Sundry ID: 2786894

Type of Submission: Notice of Intent	Type of Action: Recompletion
Date Sundry Submitted: 04/25/2024	Time Sundry Submitted: 08:54
Date proposed operation will begin: 08/01/2024

Procedure Description: Hilcorp Energy Company requests to REVISE the perforations on the previously approved RC NOI. Please see the attached procedure, current and proposed wellbore diagram, plat and natural gas management plan.

HILCORP ENERGY COMPANY
SUNRAY G 2B
FRUITLAND COAL RECOMPLETION SUNDRY

SUNRAY G 2B - PROPOSED WELLBORE SCHEMATIC (PRIOR TO DRILLOUT/COMINGLING)

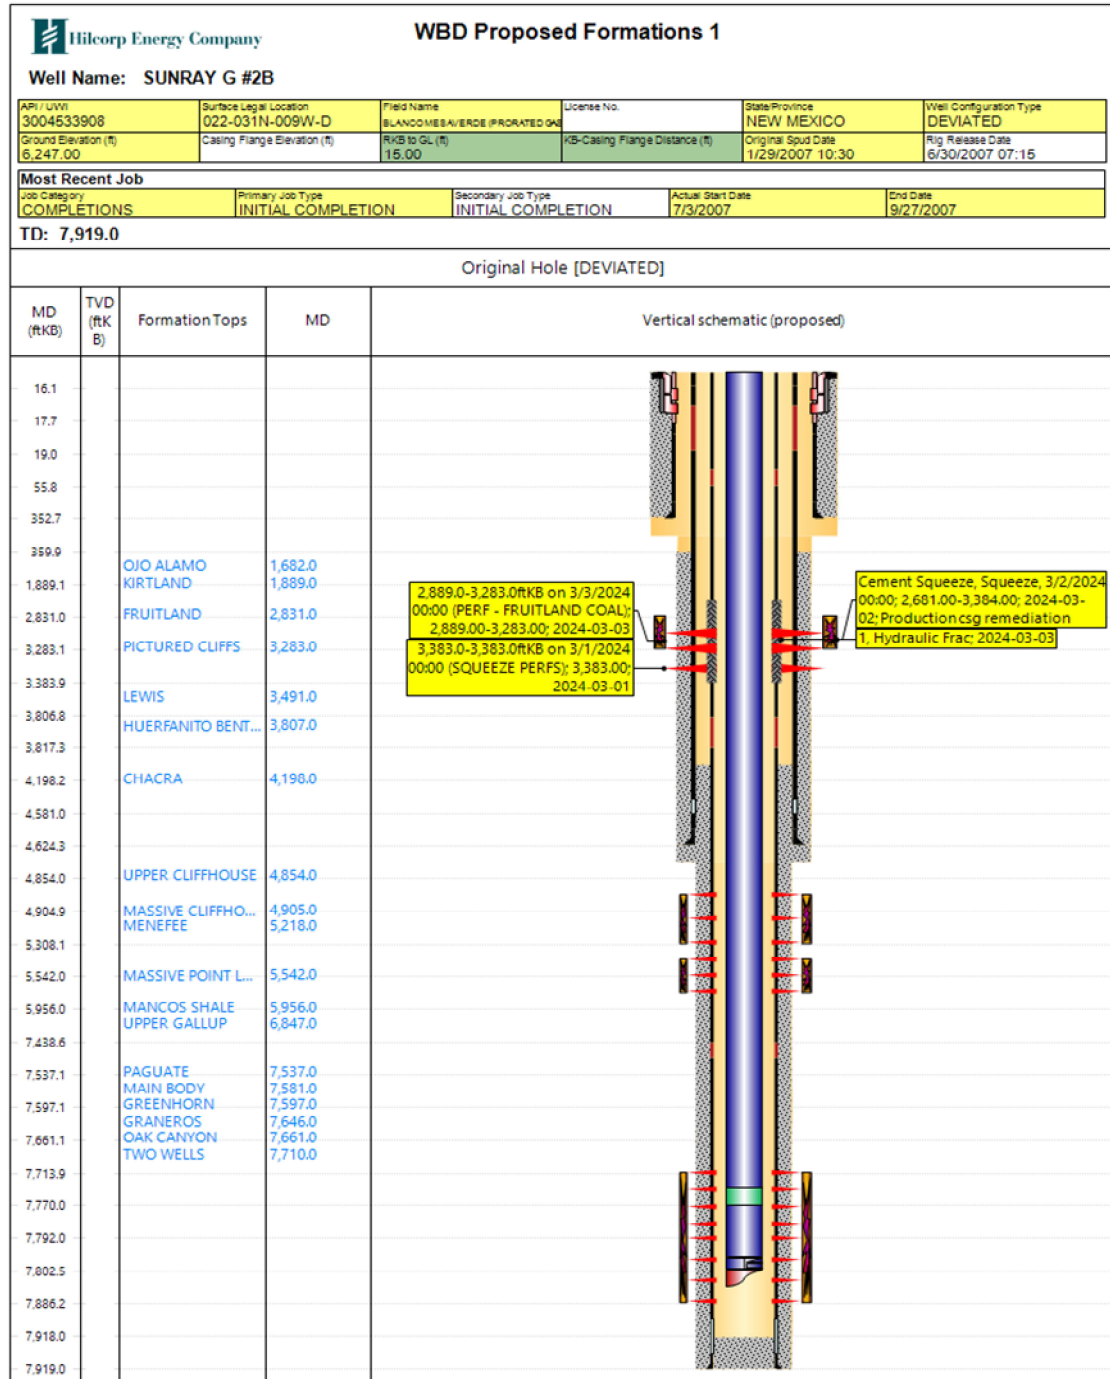
11. Pressure test the casing to **Max Frac Pressure of 5000 psi** (80% of burst on 4-1/2" 11.6# L80 is 6,240 psi)
 12. RU E-line crew. Perforate the Fruitland Coal. **(Top perforation @ 2,889', Bottom perforation @ 3,283').**
